Technical Service Bulletin

NUMBER
26-EV-007H

MODEL(S)
IONIQ 5 (NEA EV)

SUBJECT: UNDER-TORQUED RELAY BOLT – INVERTER REPLACEMENT –
DTC P1E3000

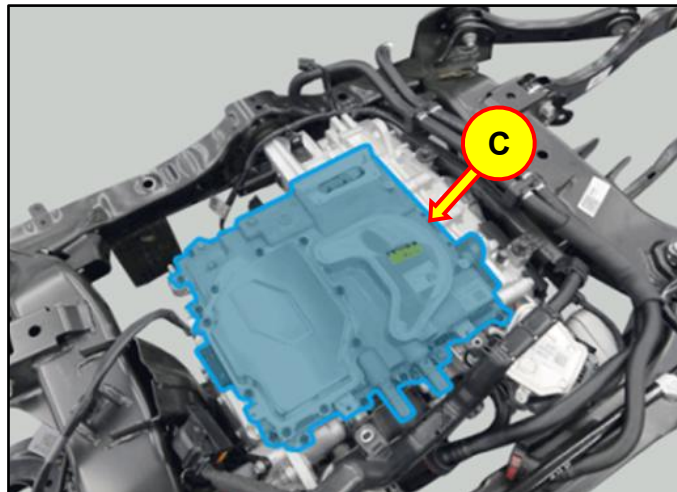
6. Remove the rear inverter assembly (C) by referring to the shop manual:

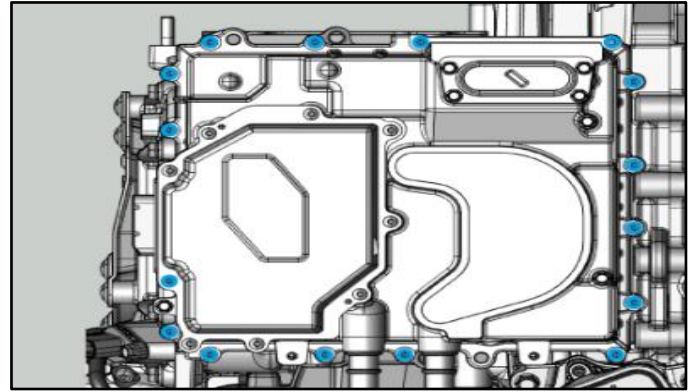
7. Install new rear inverter assembly in the reverse order of removal.

Tightening Torque:

lb-ft	6.2
lb-in	74
N.m	8.4

Use new mounting bolts for installation.
